RE: ENGINEER CERTIFICATION FOR WOMEN'S COMMUNITY ASSOCIATION
(K15-D64) ENGINEER'S CERTIFICATION STATEMENT DATED 8/17/98

Case No: (K-15/D64)
Site Location: Lead and Elm
Project Title: **Women's Community Association**

**Engineer's Certification
Women's Community Association**

GRADING PLAN

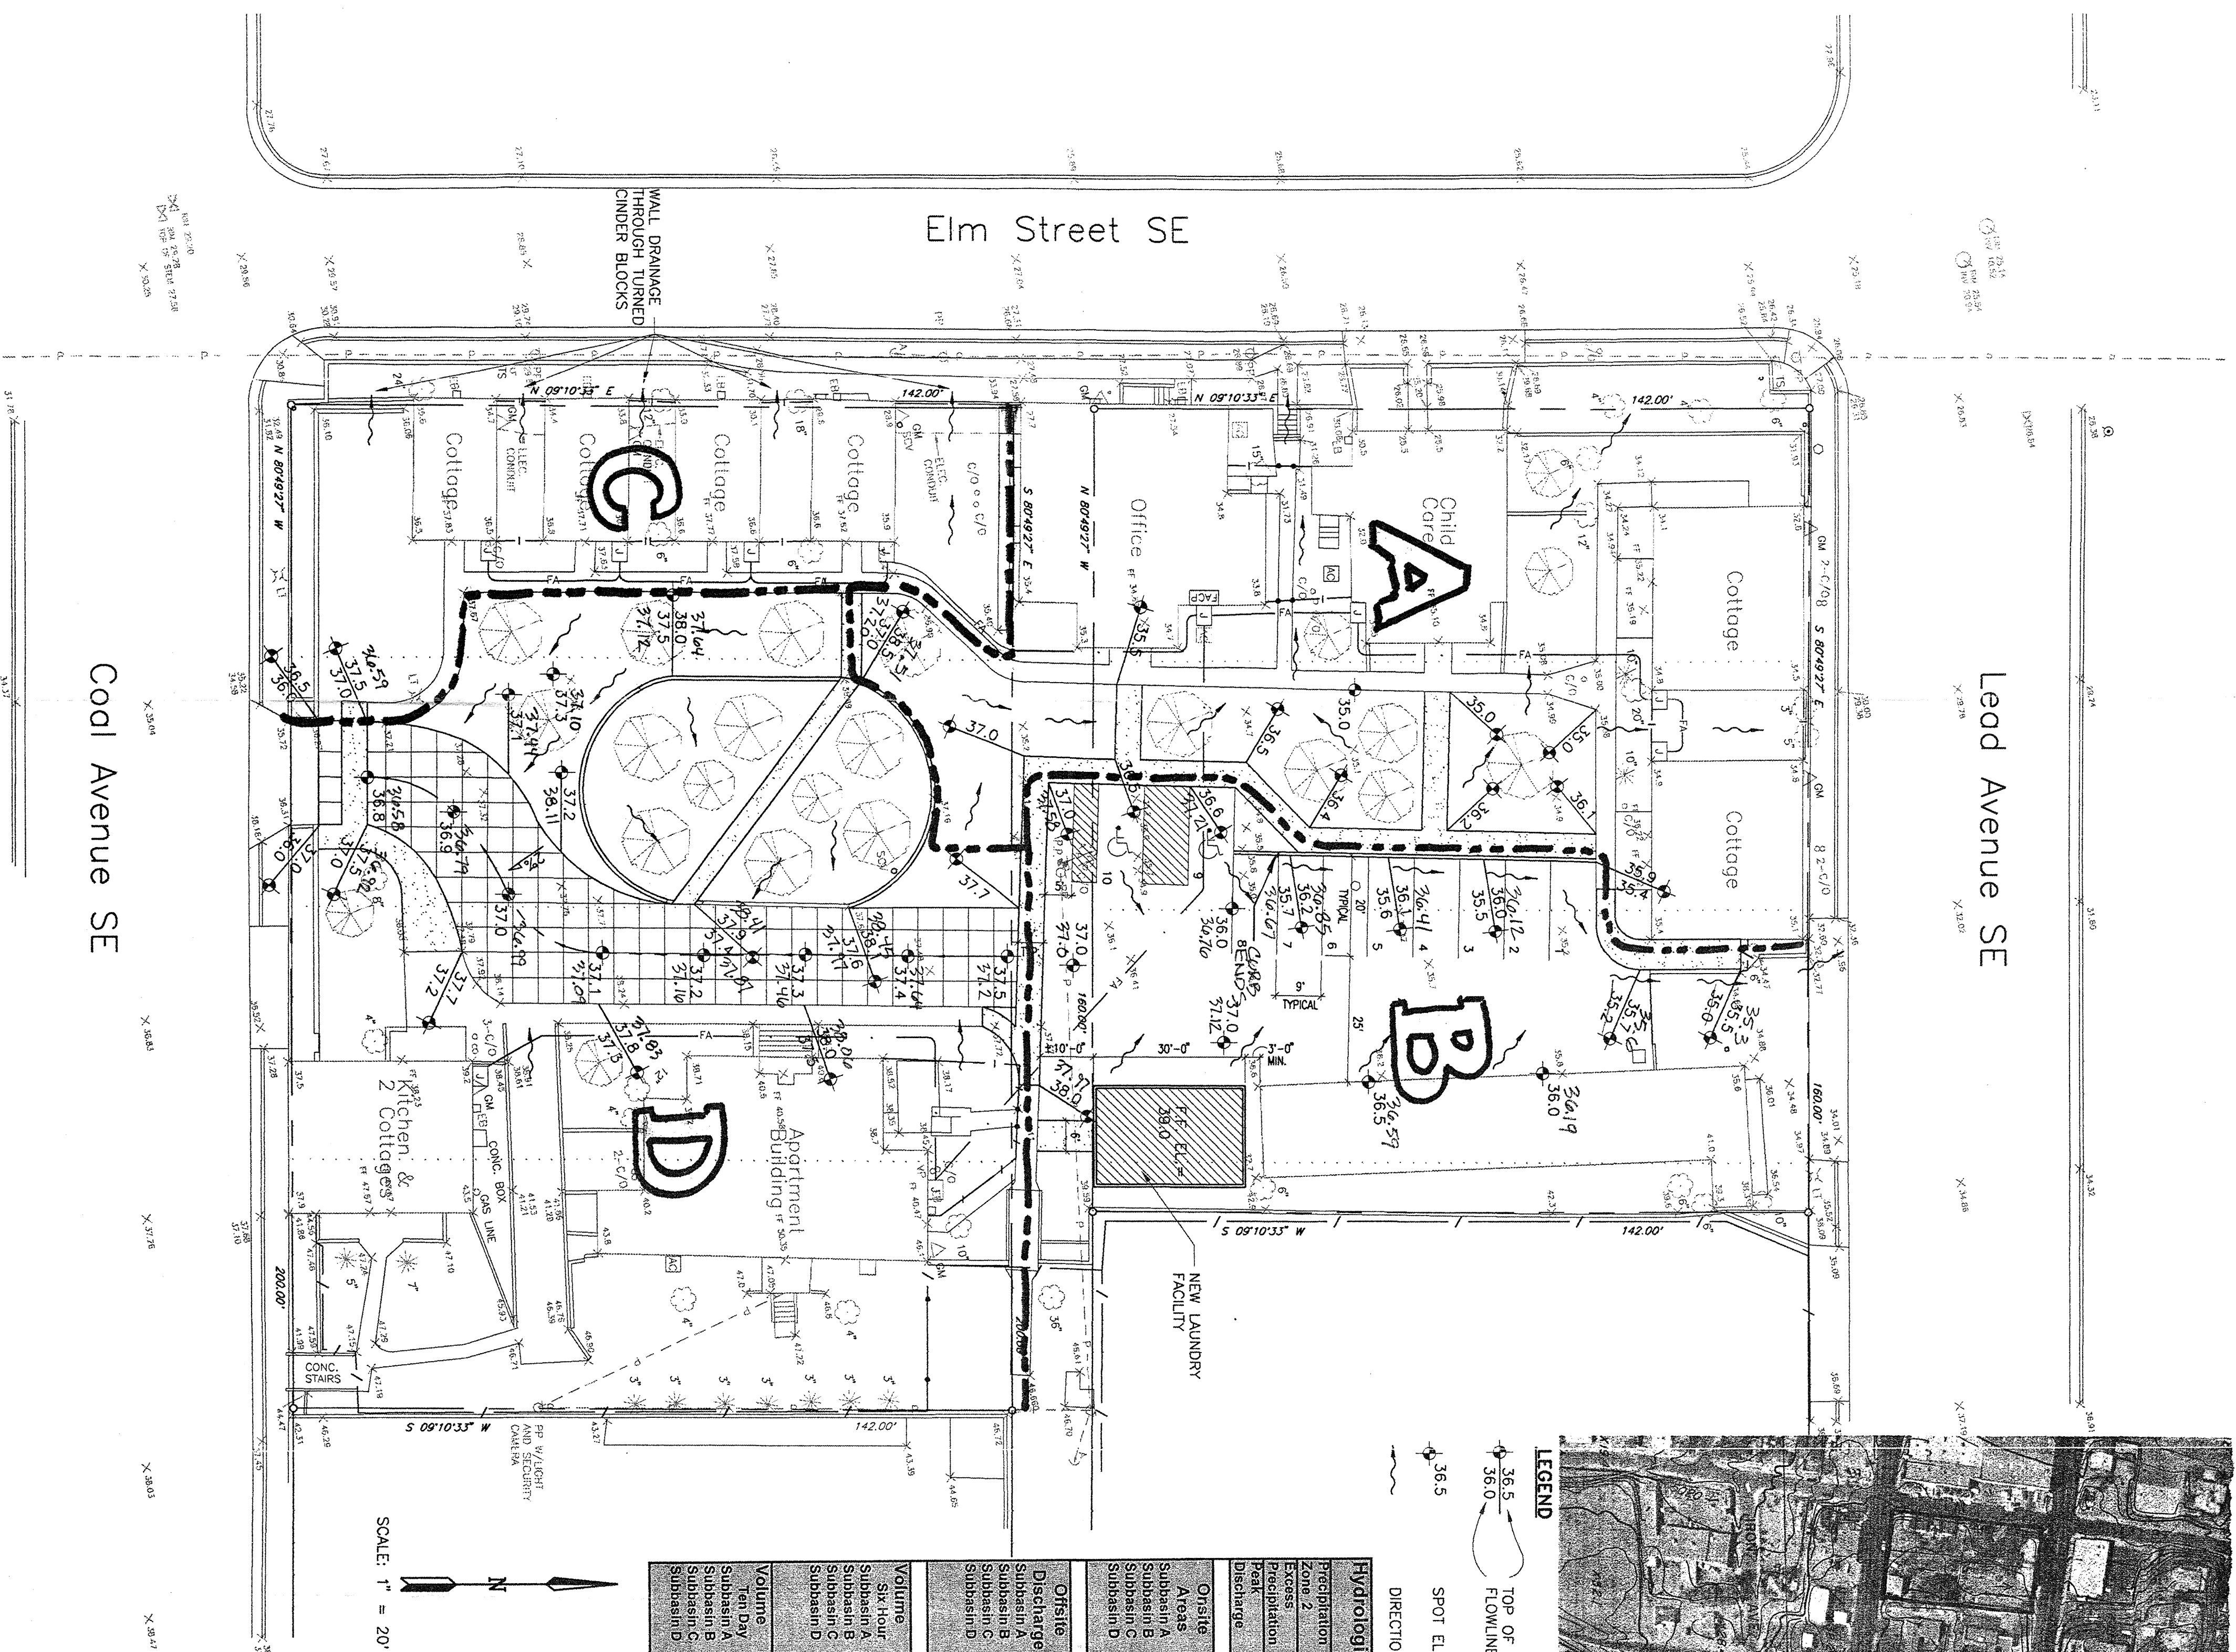
This letter is in response to your comments dated 6 May 1998. The as-built drawing submitted previously did not indicate elevations on the plan, but showed only instrument heights as indicated by the contractor. I did not transpose these points into elevation at that time. Since the previous submittal, I hired a surveyor to establish as-constructed points. The following are the responses to clear up any other questions or concerns you may have:

1. As-built designation is based on the Benchmark as described on the plan.
2. The new improved "as-built" grades (elevations) do show Basin "B" draining to Lead.
3. The purpose of the sand trap/cleanout is for the proposed laundry facility that is the basis of this whole project.
4. With the new improved "as-built" elevations as shown, the plan as approved is now in substantial compliance.
